# STAFF RECOMMENDATION

C. Kelly  
NCPC File No. 7244

## FORT BELVOIR – SOUTH POST PERIMETER FENCE

Route 1 between Mount Vernon Memorial Highway and Gunston Road  
Fairfax County, Virginia

**TYPE "D" FENCE ELEVATION**

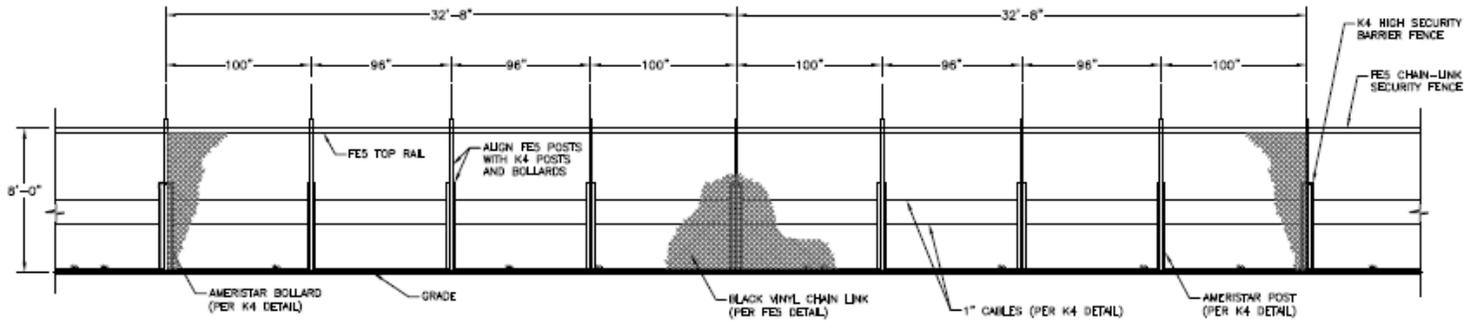
- **Evaluate the use of Type C fencing for the area adjacent to Casey Road and the baseball field as this area is visible from public space;**

The narrative for the project indicates that the Army proposes to use Type D fencing, the chain link fencing, for the segment of the fence adjacent to the baseball field due to the possibility of the conflict with the Route 1 widening. However, staff recommends that the Army evaluate the use of Type C, the ornamental fencing, at this location as the fence is set back from Route 1 and can be visible from off-post locations.

**Fence Type Locations**

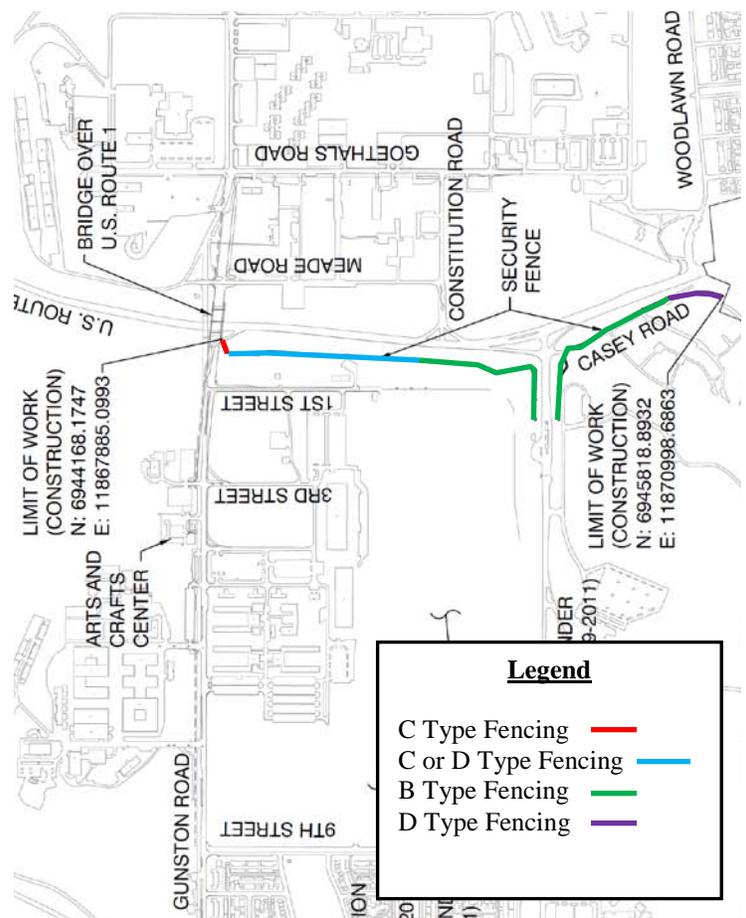
- **Evaluate aligning the fence to the south of Casey Road to lessen any potential conflict this portion of the fence would have on the U.S. Route 1 widening project and to allow for more flexibility on the location of the future Potomac Heritage National Scenic Trail;**

The current proposed fence location follows the northern edge of Casey Road from Belvoir Road to the baseball field. Relocating the fence to the south side of Casey Road may allow an additional buffer area between the widening of U.S. Route 1 and the fence to allow for potential utility work in the area, as indicated by Fairfax County, and greater flexibility for the design and location of the Heritage Trail.

**Proposed Alignment of the Potomac Heritage Trail through Fort Belvoir**

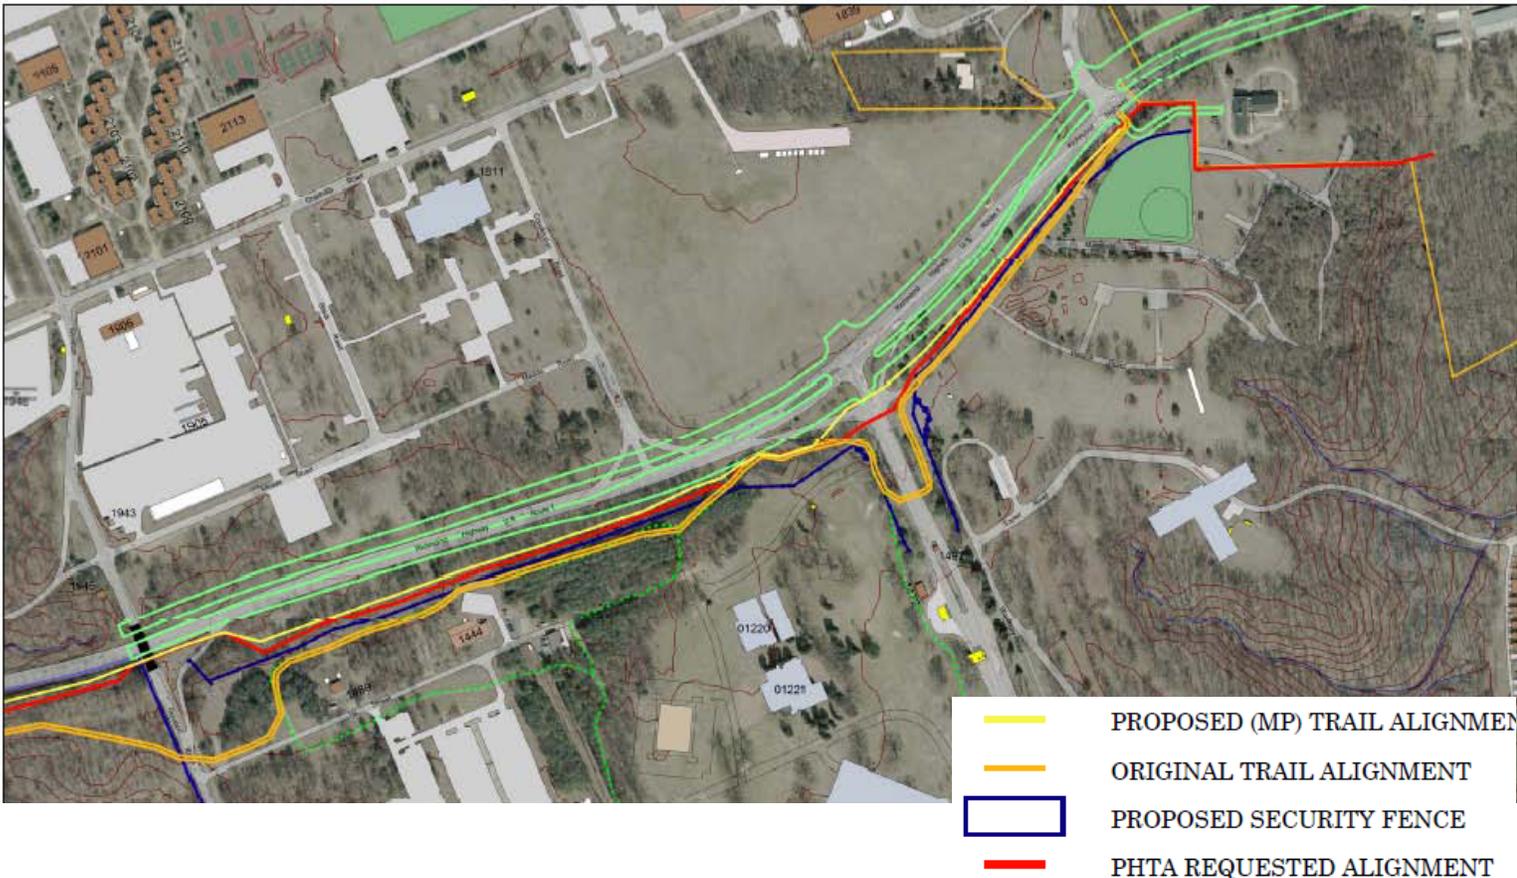
Staff notes that the fence segment from Belvoir Road to the installation’s boundary allows for the least amount of land between the expanded U.S. Route 1 and the fence line; and therefore, We encourage the Army to work with the NPS on the fence line location for this segment in order to examine if there are opportunities to allow for additional land area between the fence line and Route 1 to provide for flexibility in the location of the Heritage Trail.
